BEFORE THE COMMISSIONERS ON BEHALF OF OTAGO REGIONAL COUNCIL

Application RM20.280 by
Dunedin City Council for
resource consent for the
construction and operation of a
Class 1 landfill at Smooth Hill

Statement of Reply of Hilary Lennox, Consultant Planner

24 May 2022

Attachment 1: Activities within 100 m of swamp and other wetlands

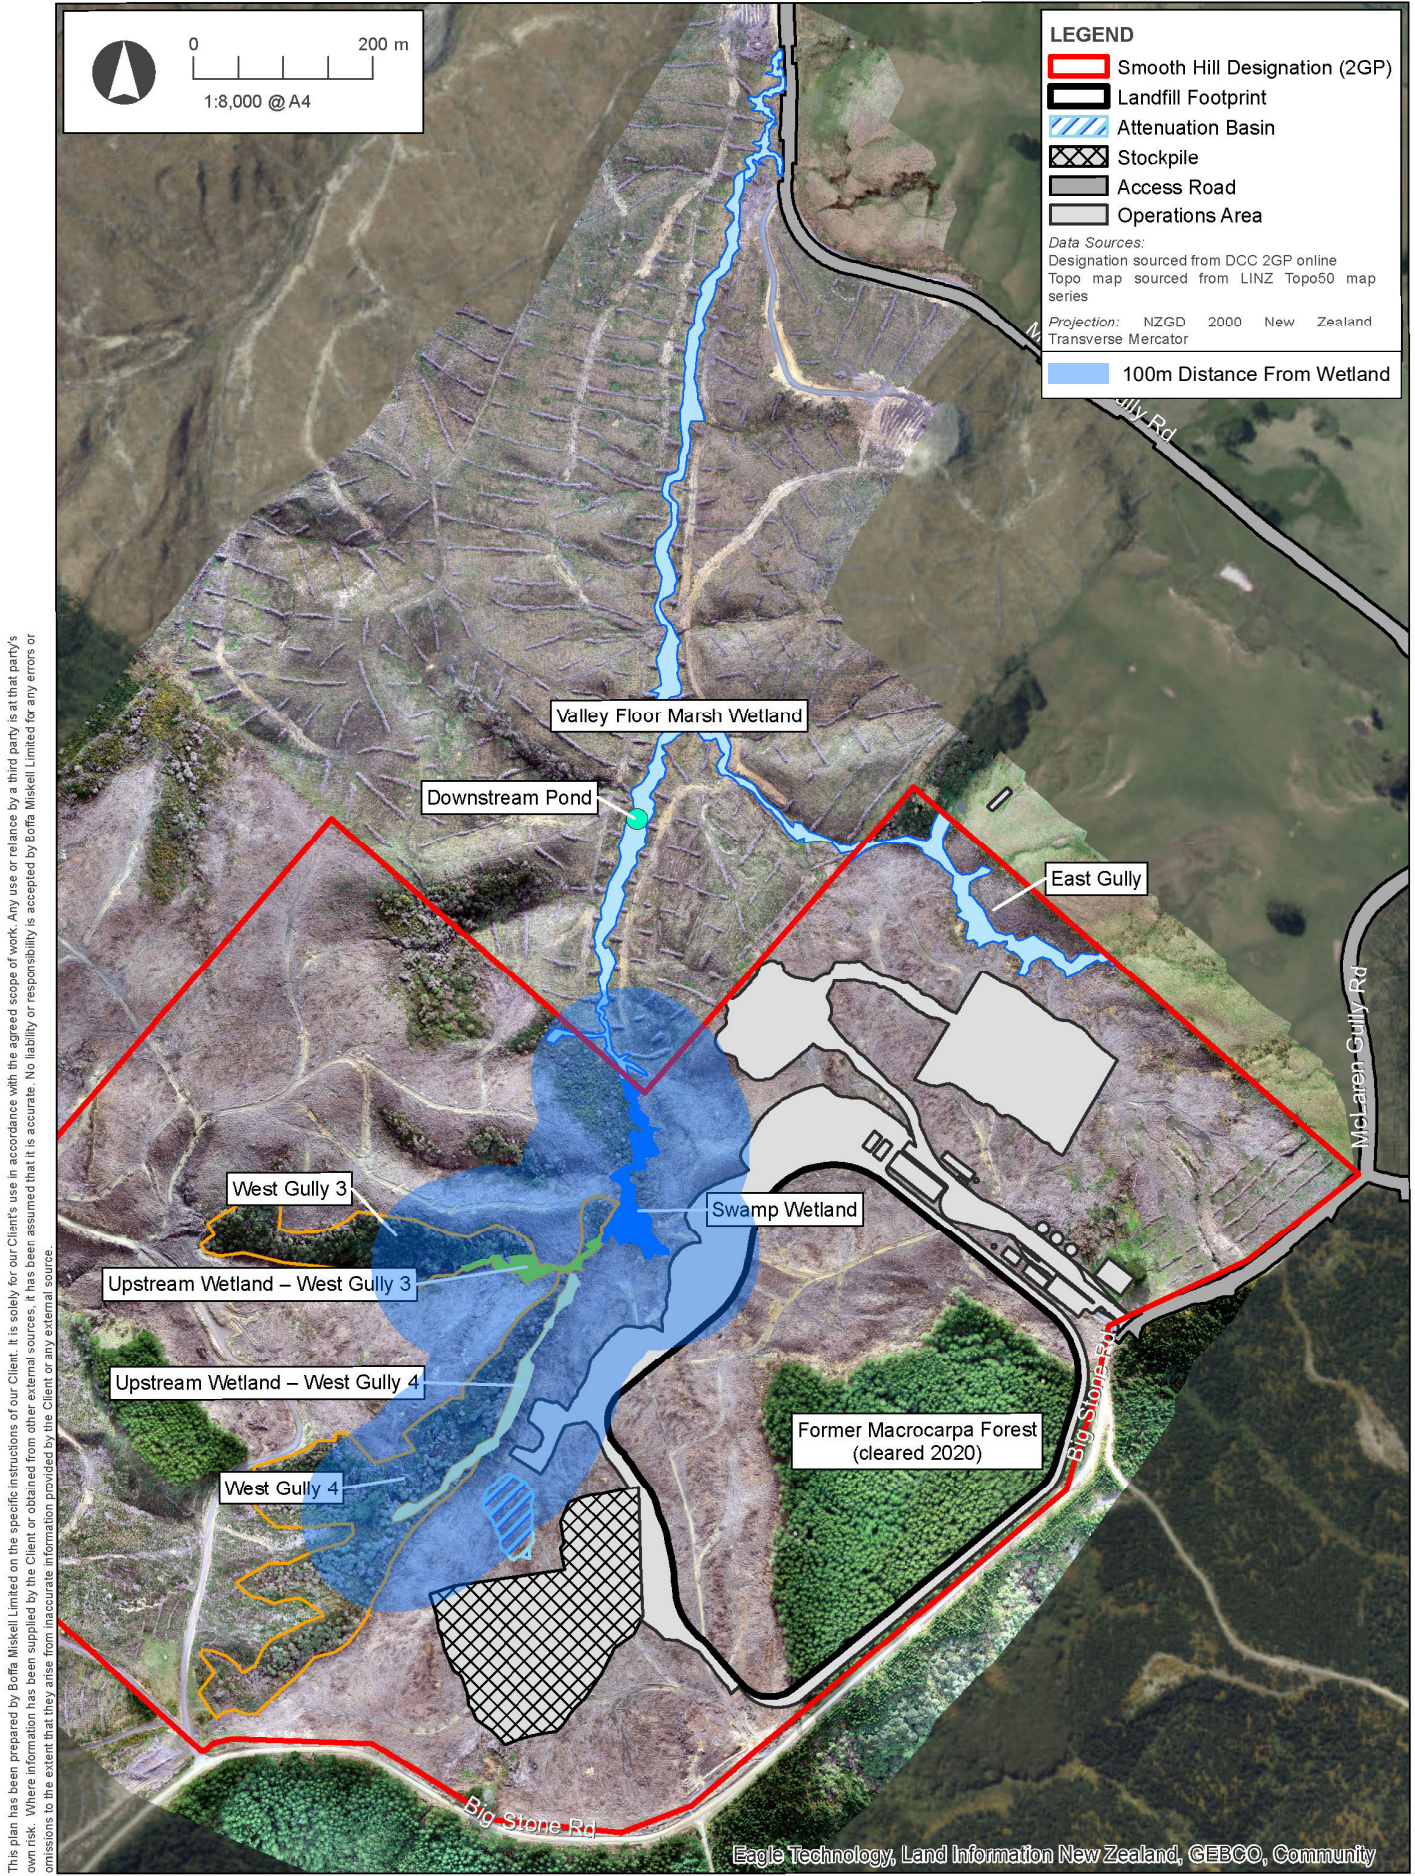
10. It is my view that a land use consent is required under regulation 52 for earthworks activities that fall within 100 m of the swamp and west gully wetlands. I cannot imagine what other type of the earthworks activities this regulation is intended to capture, other than large infrastructure projects such as this involving the construction of bunds and dams. There is no disagreement between the ORC and the Applicant regarding this.
